To: Sue Simons – Ashbourne Expert Panel Chair

From: Steph Wilson and Fraser McNutt – Barker & Associates Limited

Re: Ashbourne [FTAA-2507-1087 – Response to Item [2] as part of Minute 2

Figure 3: Location of WWTP within Tamahere Country Club outlined red

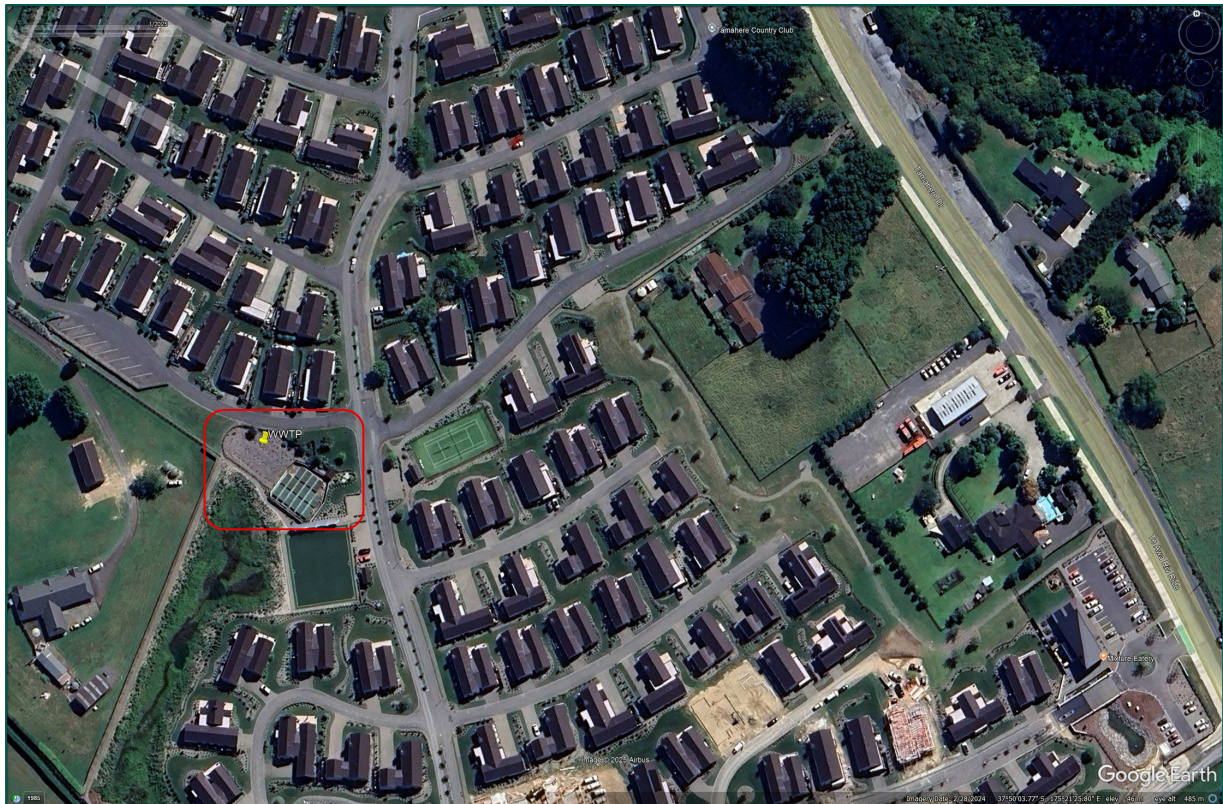
Elevation details of the wastewater treatment facility within the retirement village (and the way in which potential odour effects for adjacent villas is able to be avoided).

The WWTP is located in close proximity to dwellings and other public facilities which is common practice. An example of this is the Tamahere Country Club which is also a retirement village with a plant very close to houses, as shown in **Figure 3** and **Figure 4** below. Activated carbon filters with a small fan are proposed for odour control to prevent any effect to adjacent villas as shown on the indicative plans and Advantex vent

Figure 5: Noise Contours - Residential Earthworks and Northern Solar Farm Piling. Source: Styles Group

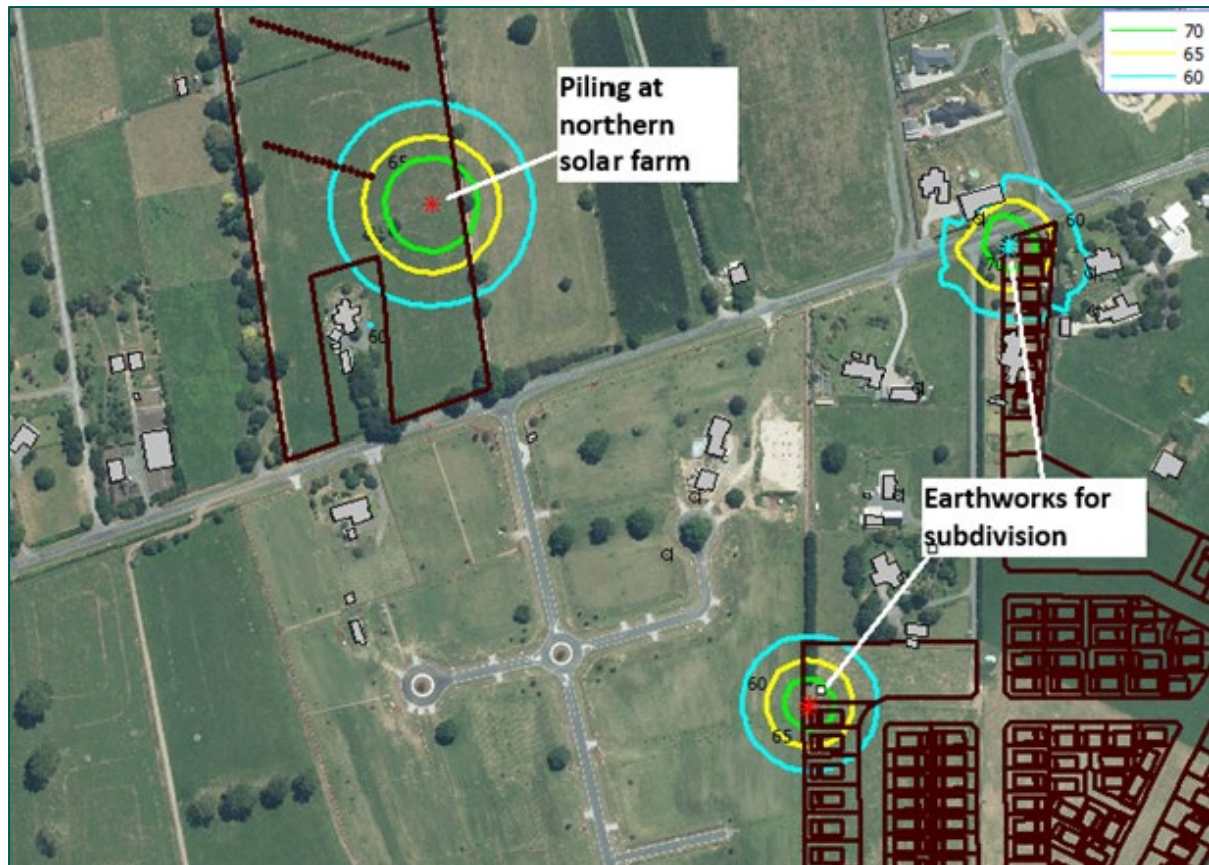
The manner by which cumulative construction effects can be identified and conditioned across all staged activities on the site.

The dwellings located at the end of Orchard Place are centrally located between the northern solar farm and the residential subdivision.

The noise contour map shows that there is adequate separation distance between the piling in the northern solar farm and the earthworks for the residential subdivision. It is unlikely that there will be any significant cumulative construction noise effects if these works occur concurrently.
